## ADDENDUM NO. 01 JUNE 12, 2023

Your attention is directed to the following interpretations of, changes and additions to the Contract Documents for the project, "HVAC Replacement" at Syracuse Hancock International Airport (SYR) in Syracuse, New York.

# PROPOSED SEATING LAYOUT - SOUTH CONCOURSE GATES 11

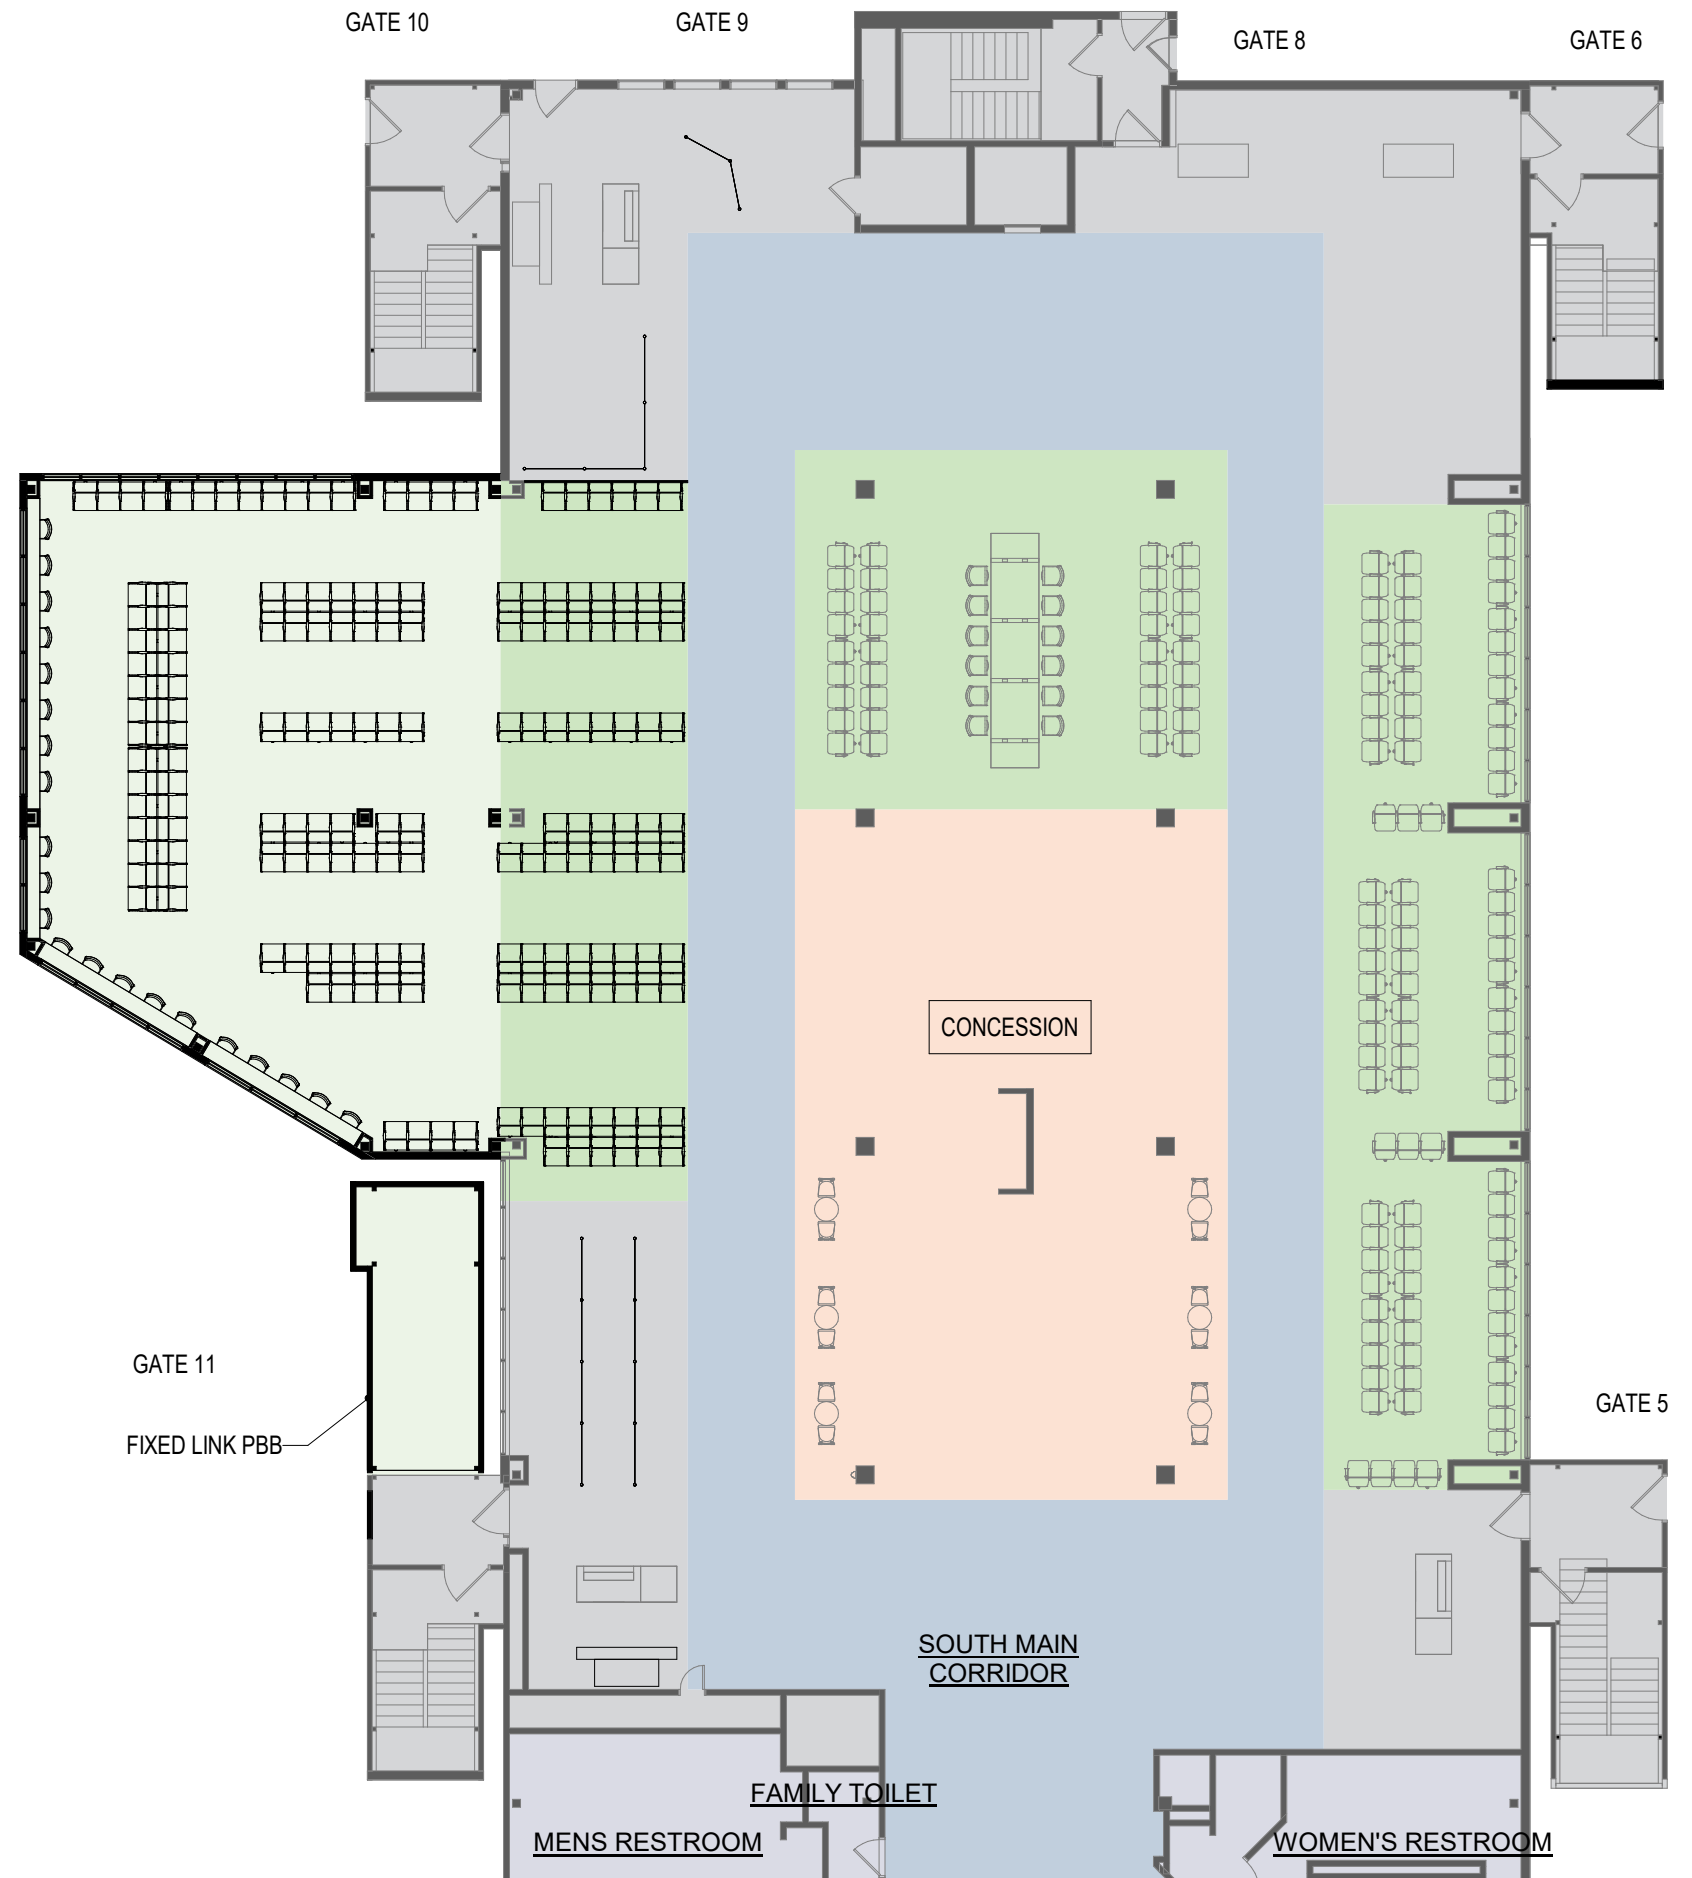
## **4. North and South Concourse Proposed Expansions**

GATE SEATING COUNT		
	EXISTING	PROPOSED
GATE 9-11	99	189

# PROPOSED SEATING LAYOUT - NORTH CONCOURSE GATES 23-25

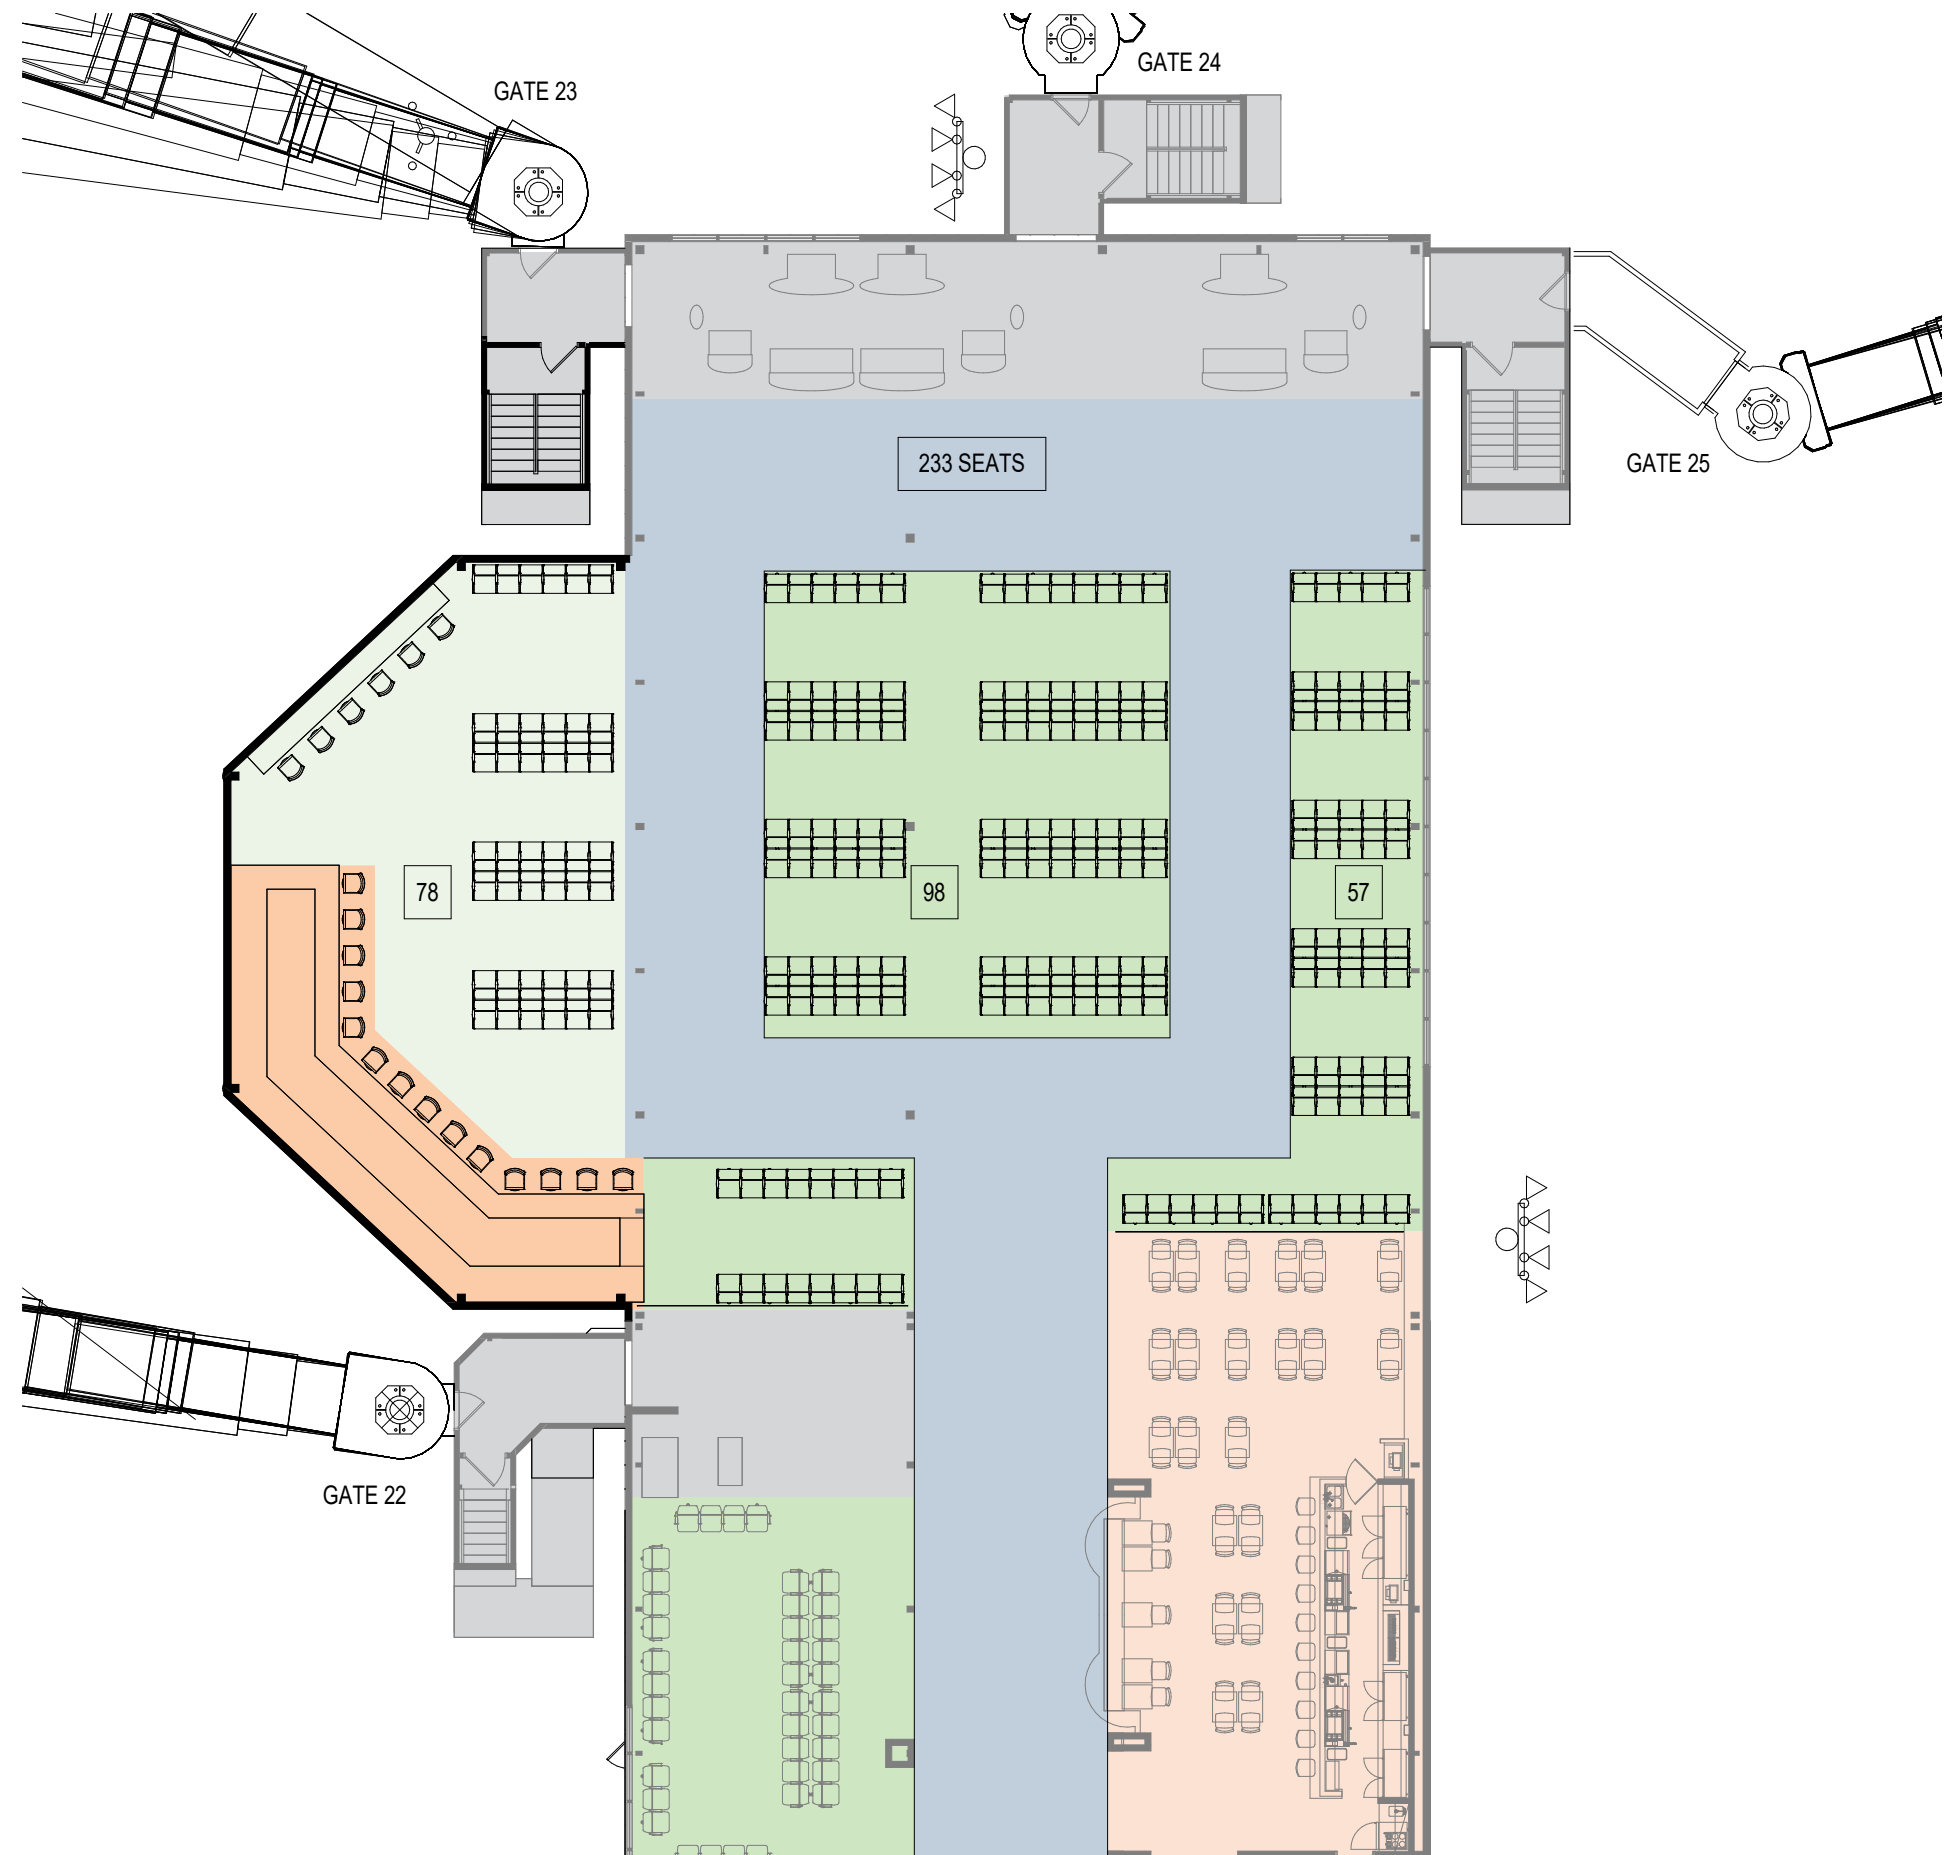
GATE SEATING COUNT			
	EXISTING	GRANT	PROPOSED
GATE 15	122	122	111
GATE 20	91	48	66*
GATE 23	45	79	78
GATE 24	104	104	98
GATE 25	48	48	57
GATE 27	0	100	86*
<b>TOTAL:</b>	<b>410</b>	<b>501</b>	<b>526*</b>

\* ADDITIONAL ± 30 SOFT SEATING SPLIT BETWEEN GATES 20 & 27
